Ref: **Planning Application 2021-91656, 39 Forest Avenue. HD1 4PL**

With reference to the above application for a single-story extension, I would like to object to the extension as currently proposed.

rear view

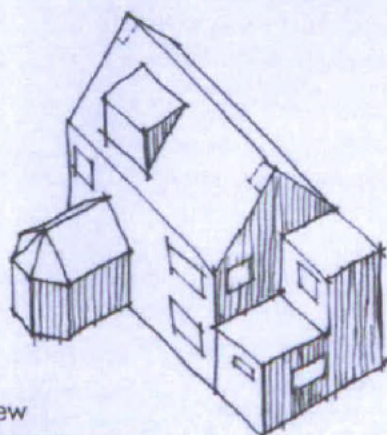
out of keeping with the area. Google Maps does not show any other properties in the immediate area that seem to have balconies on them.

Further I feel that it will take away from our amenity of the enjoyment of our home and garden due to the fact it will only be a couple of metres from our boundary and will seriously overlook our property,

The are the approximate position of the main extension building fabric with the showing the positions of the hand rails. As you can see this will result in serious overlooking when someone is stood on the balcony and is in contravention of Policy LP24(C) of the Adopted Local Plan.
